Application for Certification
Data Adequacy Supplement

Mission Rock Energy Center

15-AFC-02

Subject: Mission Rock Energy Center (15-AFC-02) Data Adequacy Supplement

Figure DA3.0-1.
 One-line Diagram
 Mission Rock Energy Center

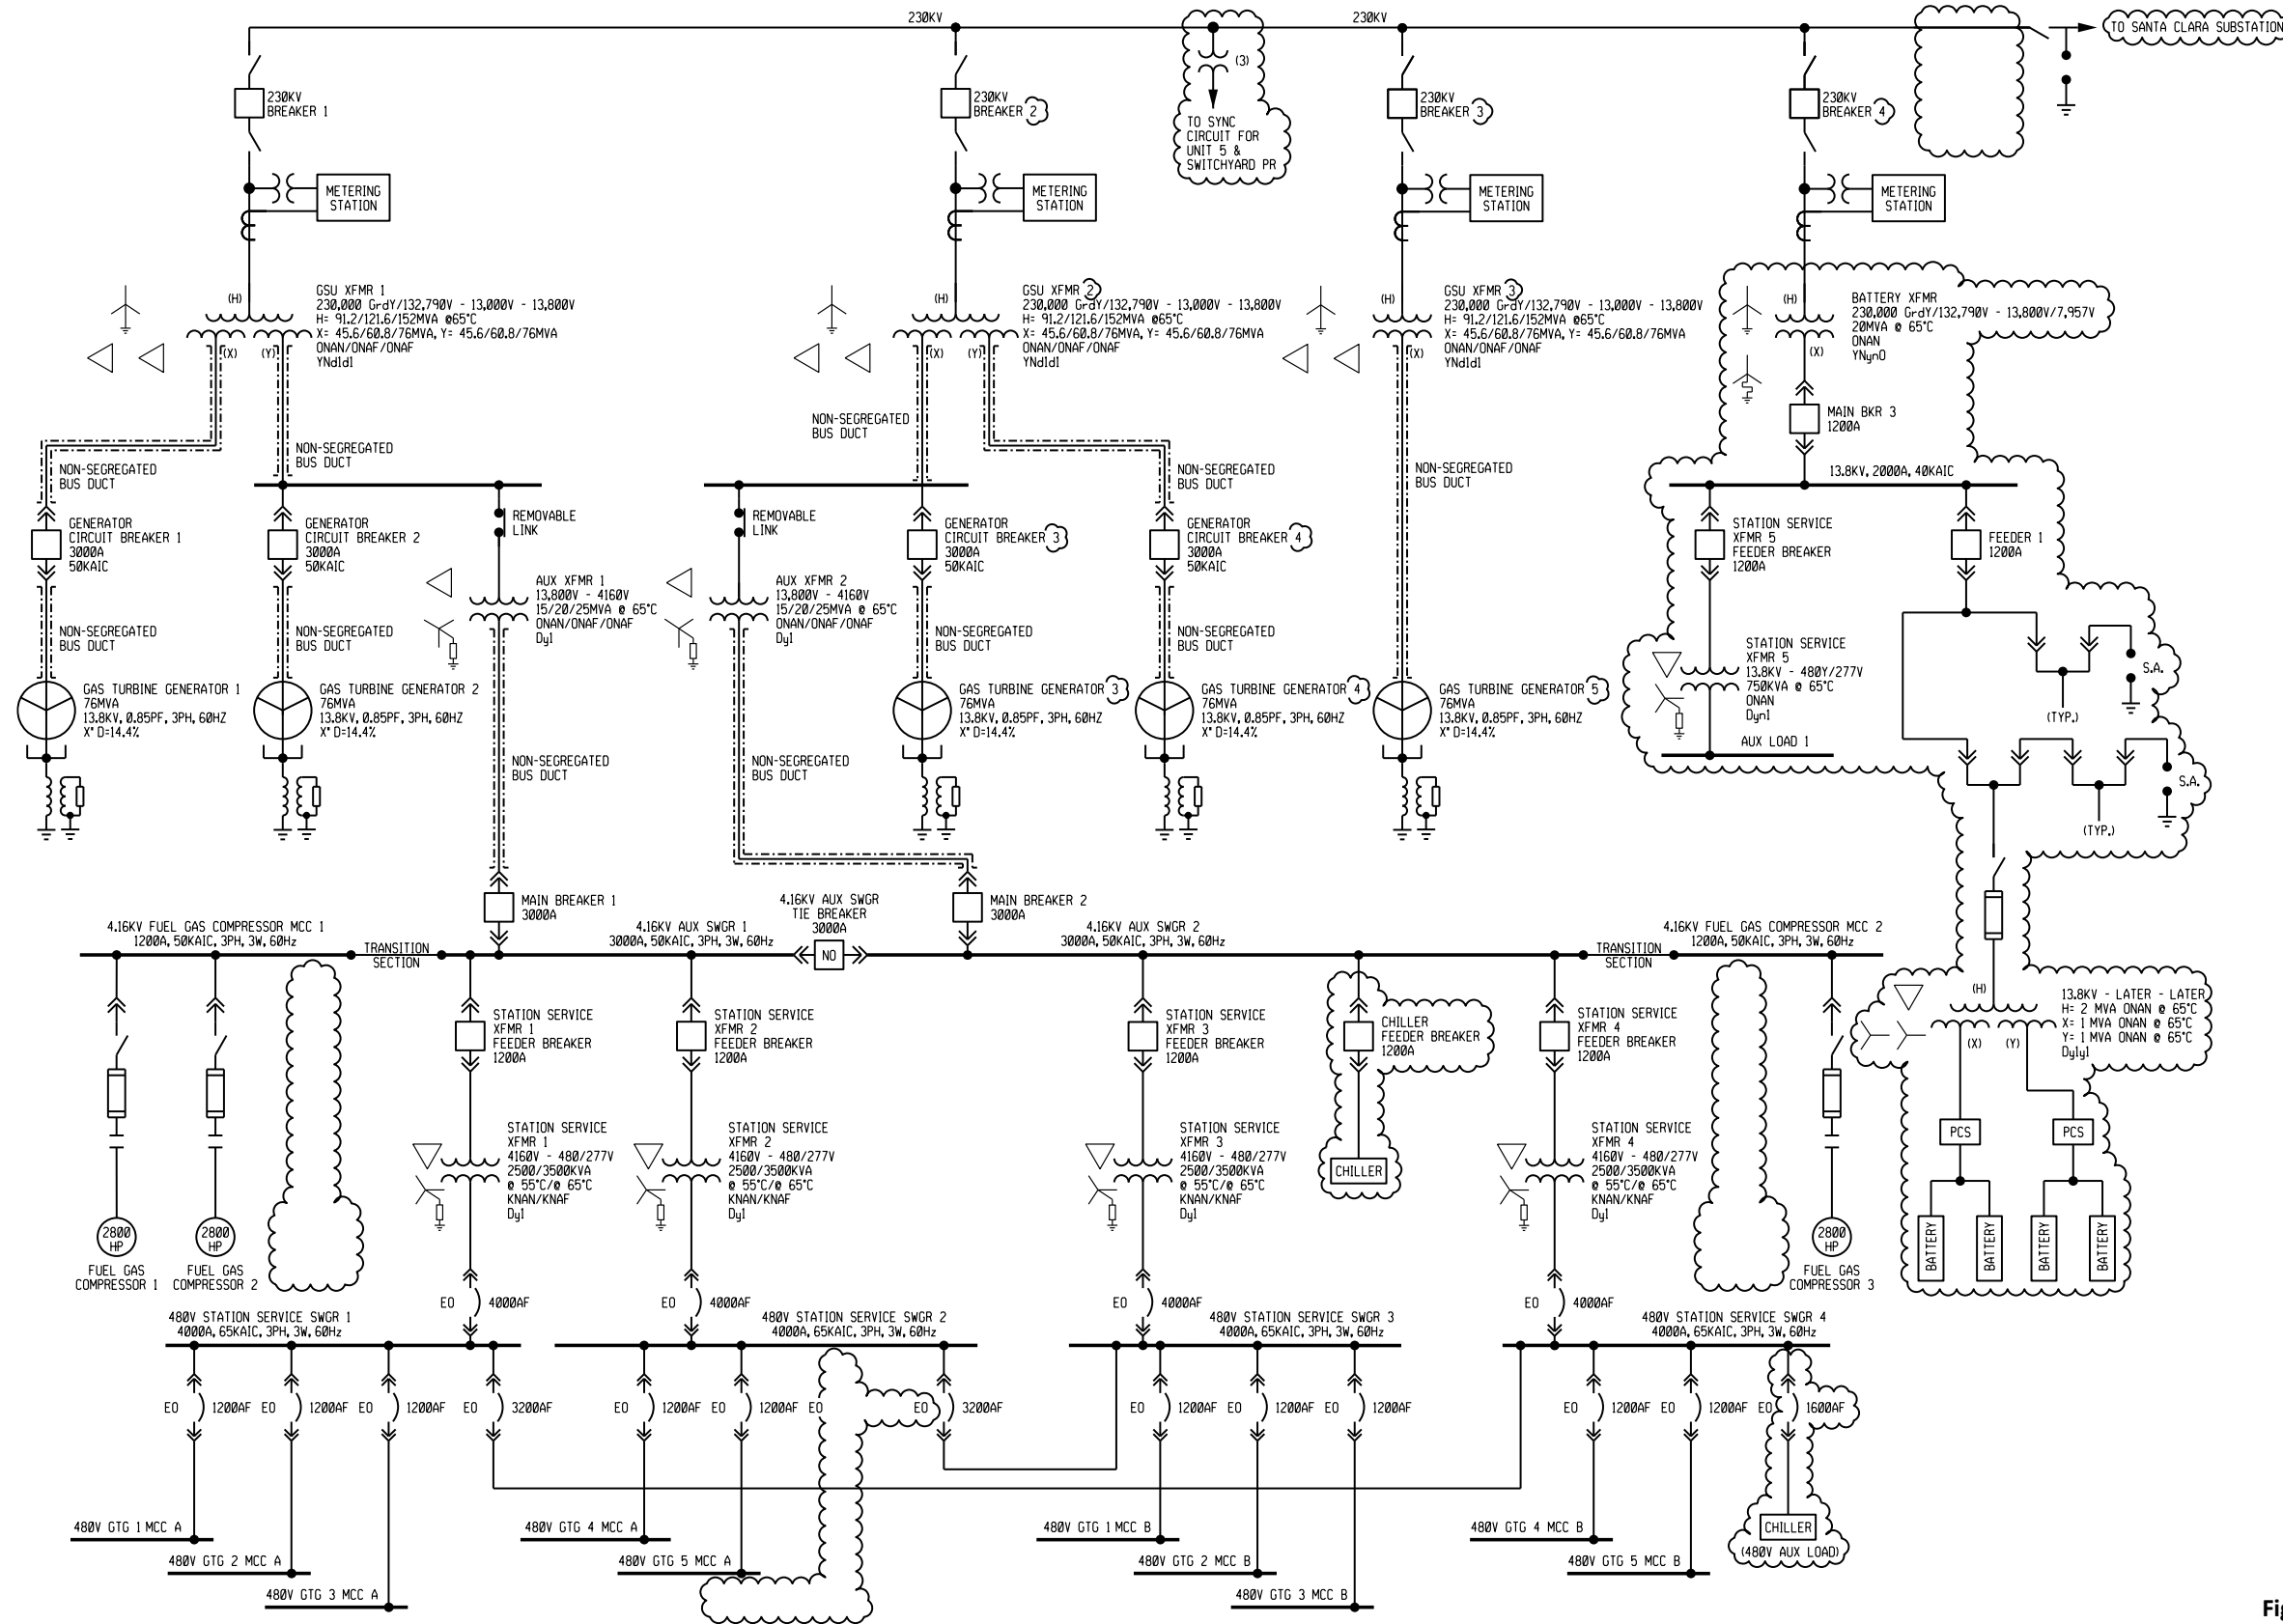
Please provide the following one-line diagrams. Show all equipment ratings including generators, transformers, isolated phase bus duct, circuit breakers, disconnect switches, and etc. required for the project.

- 1. One-line diagrams for the power plant.*
- 2. One-line diagrams for the power plant switchyard.*
- 3. One-line diagram for the Santa Clara Substation before the interconnection of the Mission Rock Energy Center.*
- 4. Provide one-line diagram for the Santa Clara Substation after the interconnection of the Mission Rock Project.*

Response: A one-line diagram for the power plant and power plant switchyard is included as Attachment DA3.0-1. Information pertaining to the Santa Clara Substation configuration and MREC interconnection will be provided in the Cluster Phase I Interconnection Study to be conducted this year by the California Independent System Operator (CAISO).

Figure DA5.14-1a.
Water Balance – Annual Average
Mission Rock Energy Center

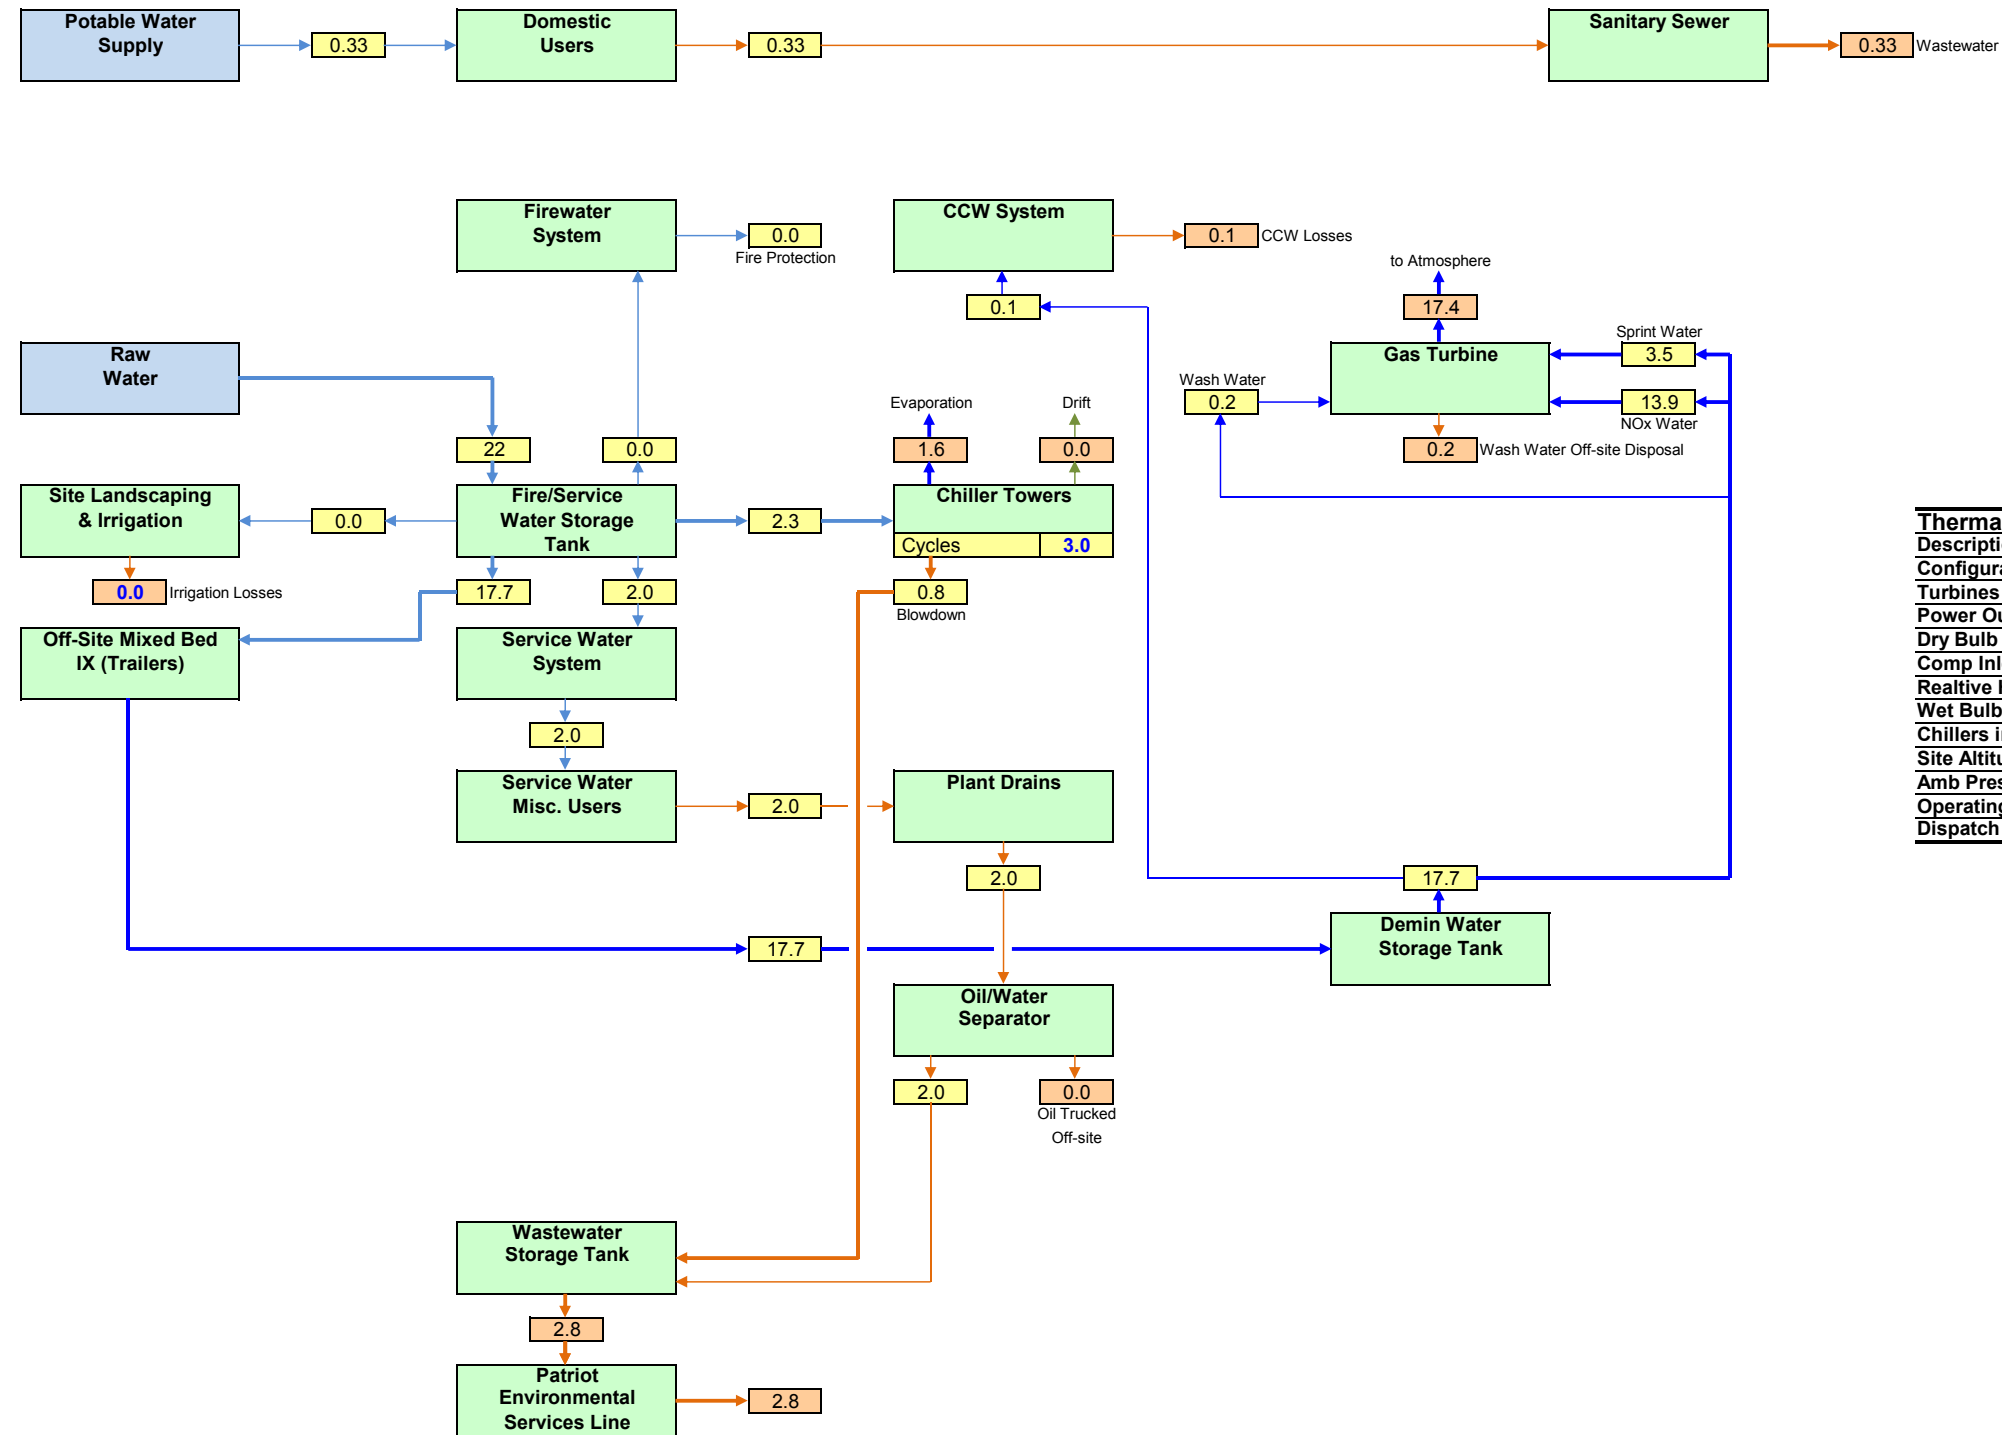
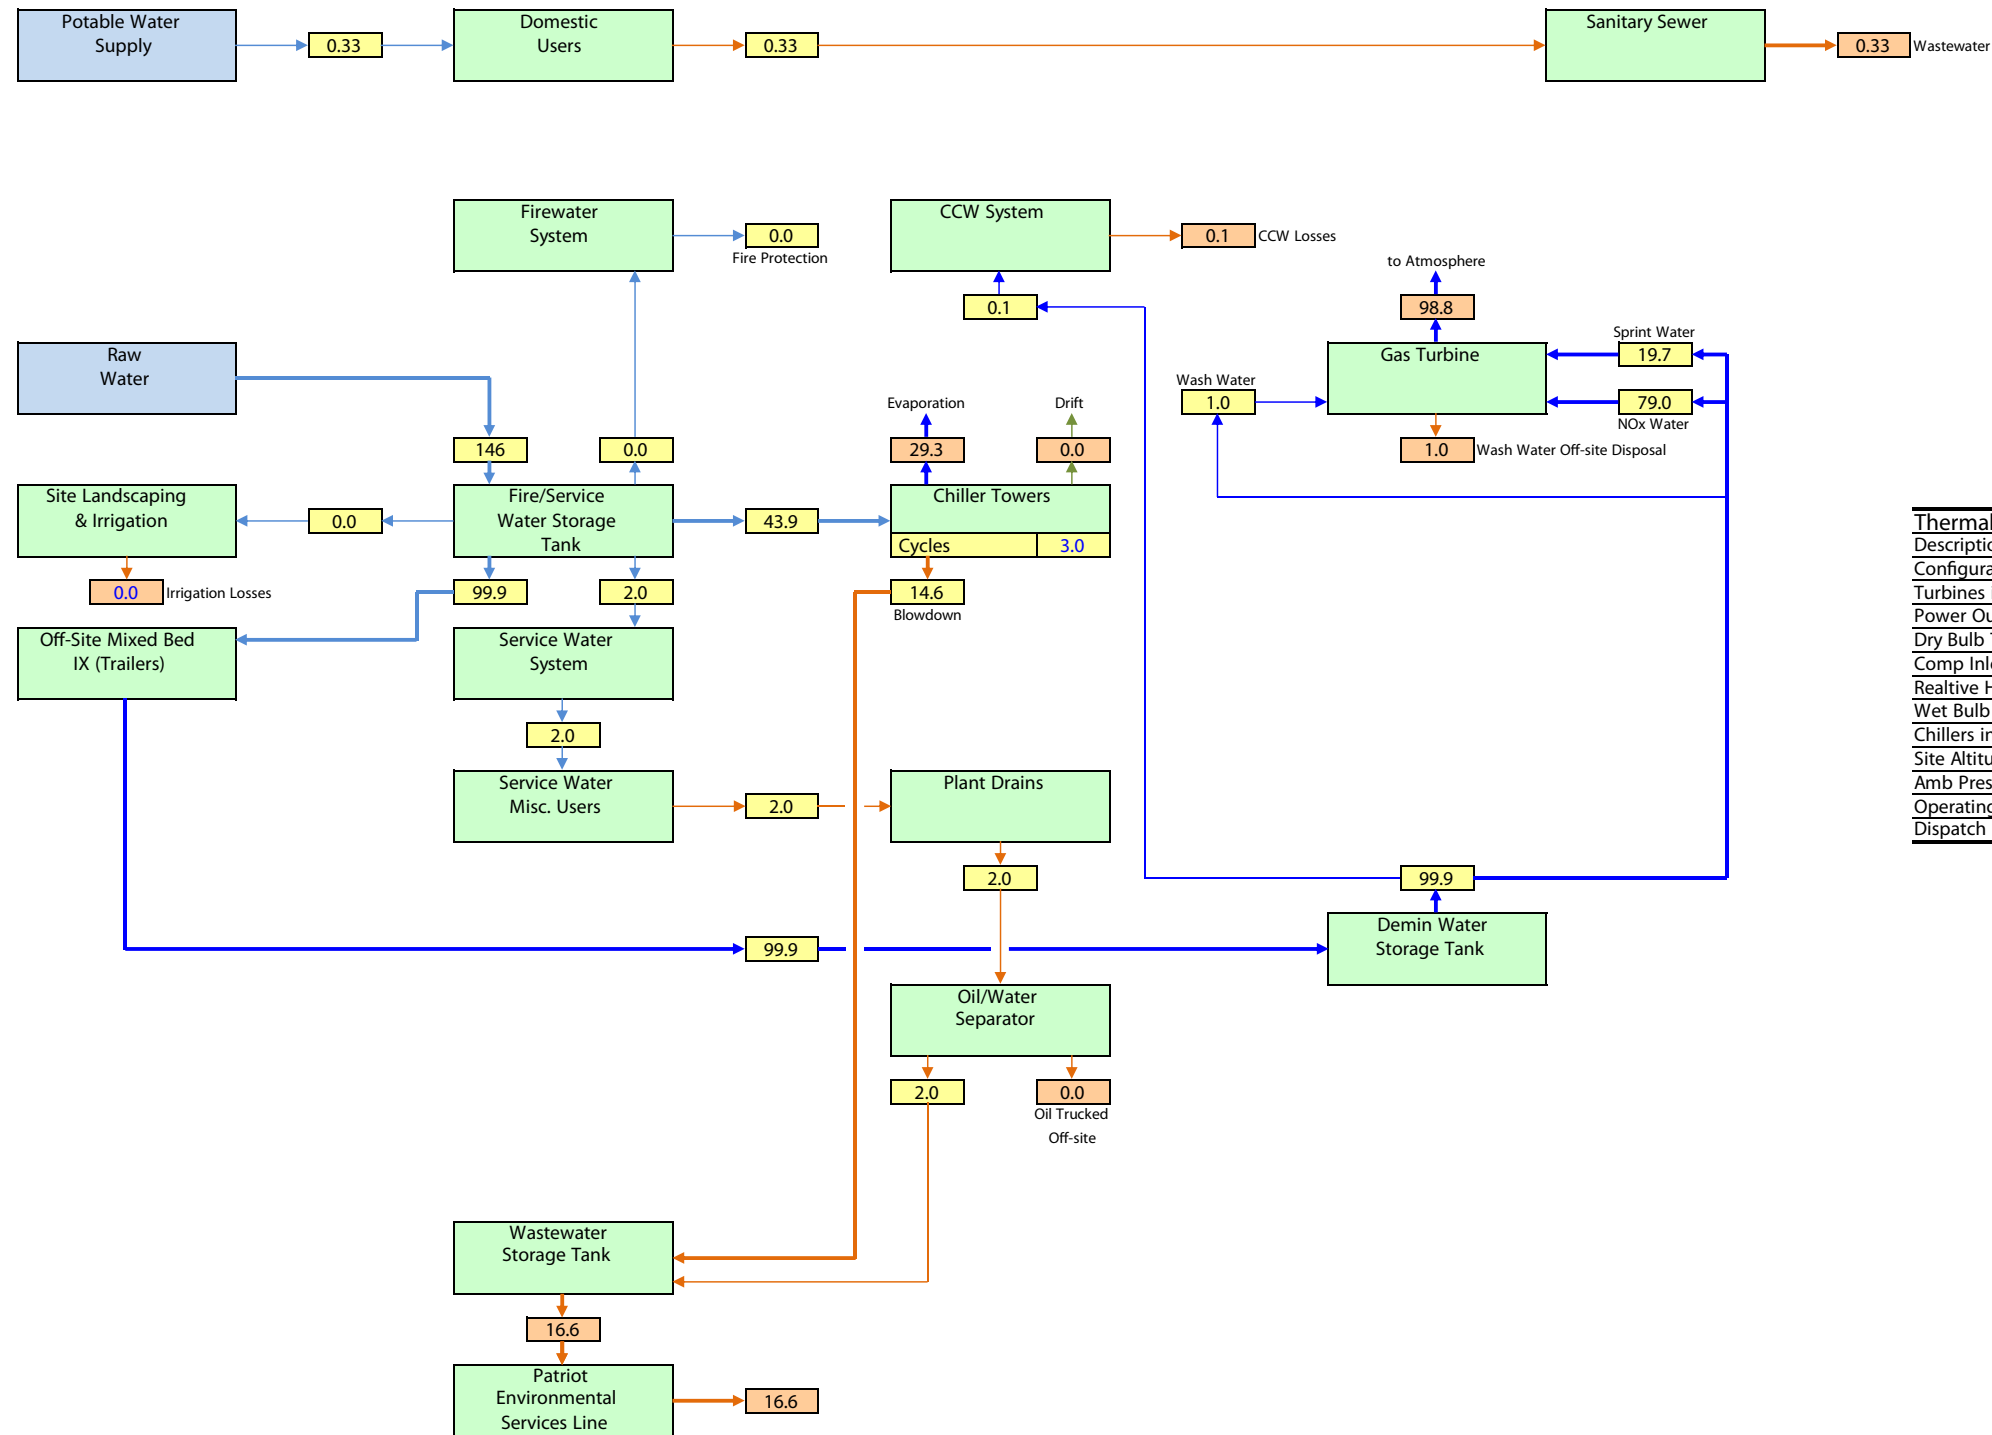
Figures 2.3-5a and 2.3-5b cited on pg. 5.14-4 under Nonhazardous Wastewater cannot be located. Figures 2.1-5a and 2.1-5b on pg. 2-17 also cannot be located. The AFC indicates these figures show the wastewater flow rates. Figures 2.1-4a and 2.1-4b show aggregate wastewater flow rates but do not show the flow rates for each of the waste water streams described in Section 5.14. Please revise the appropriate AFC sections and figures to show the separate and correct wastewater flow rates.

Response: The industrial wastewater flows are shown in Figures 2.1-4a and 2.1-4b and these are the correct figure citations for the water balance figures. These water balances show all of the applicable wastewater streams described in Section 5.14 except for the sanitary wastewater stream, flows for which are listed in Table 2.1-1. Sanitary wastewater will be disposed of by storage in a septic tank and then trucked off-site by Patriot Environmental Services (formerly Green Compass Environmental) or another qualified waste hauler. Please note that the waste streams described in Section 5.14 and listed in Table 5.14-2 are for the most part waste streams not amenable to description in terms of flow rates. They are instead described in the table using a variety of estimated quantity descriptions. For example, the rate of metal/resin use for water deionization is 173 trailers per year. Attachment DA5.14-1a contains the water balance figures, revised to include the sanitary wastewater stream.

Sanitary waste is quantified in Table 2.1-1. Attachment DA5.14-1 contains the water balances, revised to show the sanitary waste stream.
